PALM BEACH COUNTY
BOARD OF COUNTY COMMISSIONERS
AGENDA ITEM SUMMARY

Motion and Title: Staff recommends motion to approve: Change Order No. 1 to the Contract with Hinterland Group, Inc. (R2012-1421) for the Wastewater Lift Station Rehabilitation project increasing the contract price by \$75,879.02 and a 90 day time extension.

WASTEWATER LIFT STATION REHABILITATION
PROJECT NO. WUD 11-038
CHANGE ORDER NO. 1

SCOPE OF WORK
(ALL AS LUMP SUM)

LIFT STATION No. 5243
PROPOSED SITE PLAN
AND SECTIONS

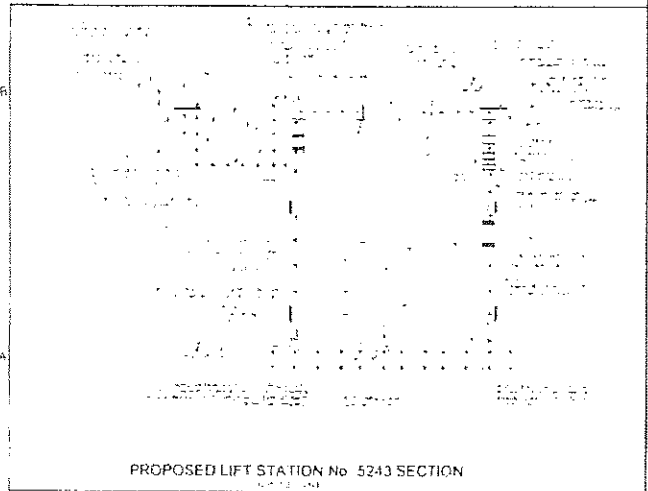
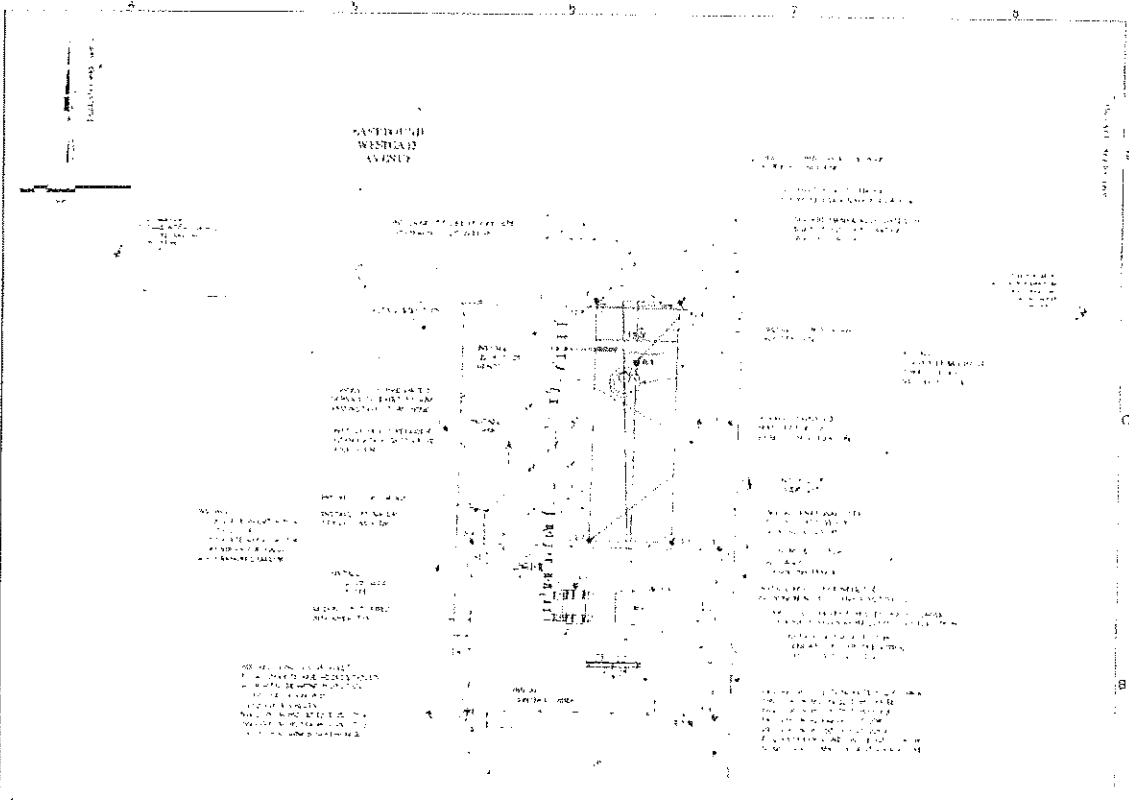
Description of Claim: The piping at LS 5243 will be reduced from 12" to 8" from the bases through the reducer at the force main connection, as directed in the response to RFI #10. This cost will be credited to the county as a 50/50 cost savings since it was offered to the County in this manner in RFI #1. The cost for restocking valves that have already been purchased will also be deducted from the 50% credit to the county.

Description of Claim: The valve vault at LS 5243 will be upsized from 5'x7' to 6'x8' in accordance with the county response to RFI #10.
